Technical Bulletin

Bulletin Number: 363 Revision Number: R-01

SUBJECT: POWER INTERRUPT SWITCH ASSY.

MODELS AFFECTED: DNCB Venders serialized 0001-3128BN and up.
DNCB Venders serialized prior to 0001-3128BN.

Figure 1

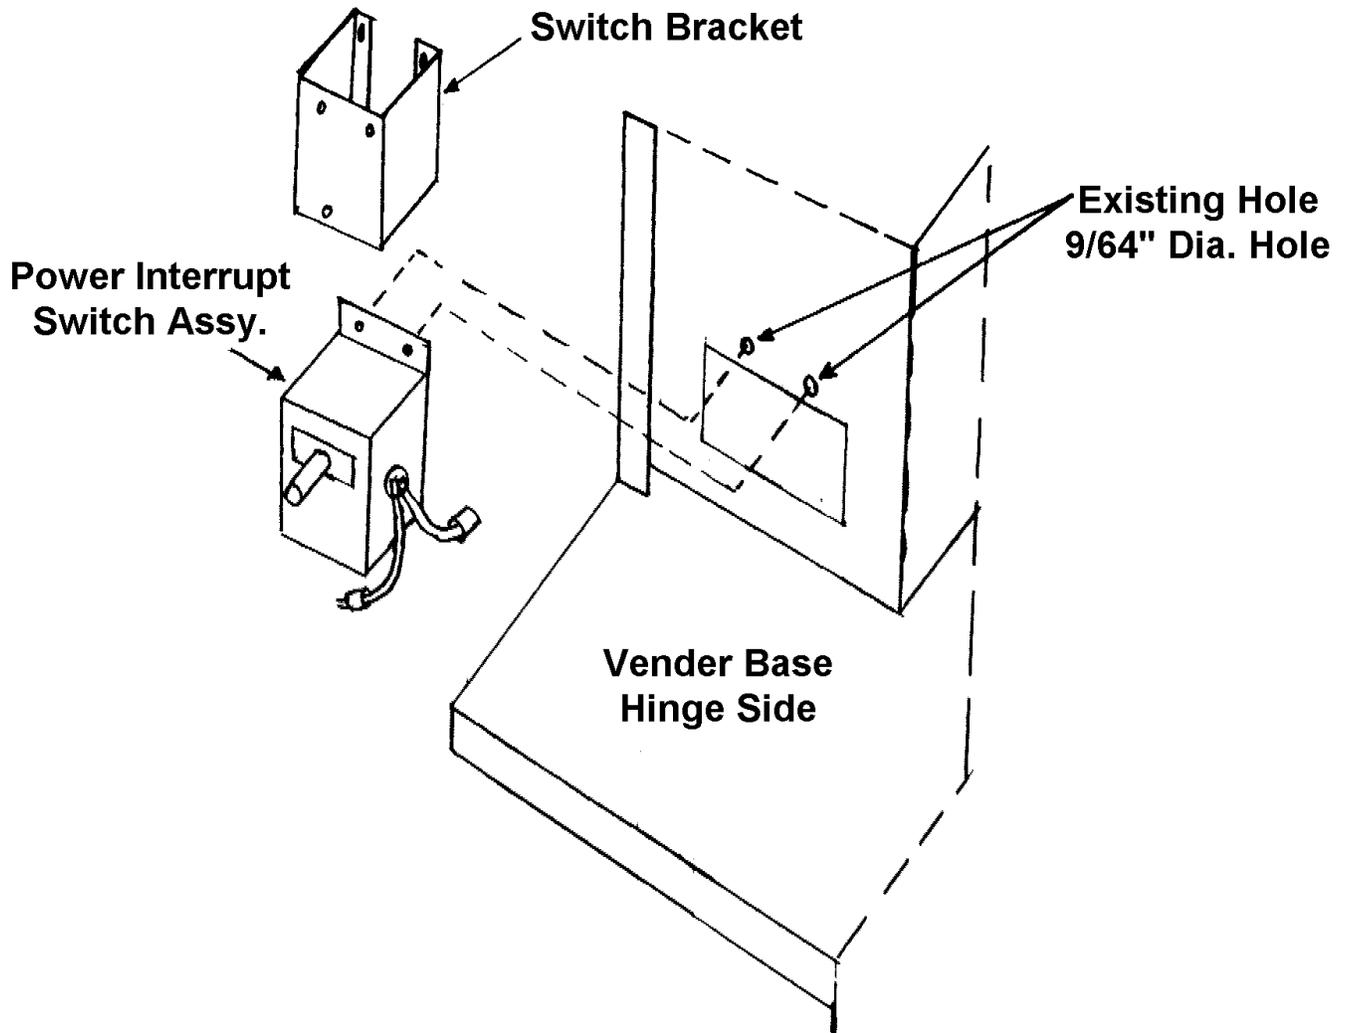
3. Locate the two existing $\frac{9}{64}$ " diameter holes in the left base box. See figure 1.
4. Place the switch bracket (609,030,04x.x3) in position and secure with two #8-18x½ phil pan screws.

5. Place the power interrupt switch assembly in position:
 - In venders serialized 0001-6368DU to 814-6452AW mount switch assembly to switch bracket.
 - In all other venders mount switch assembly to the two existing $\frac{9}{64}$ " diameter holes in the left base box. See figure 1.
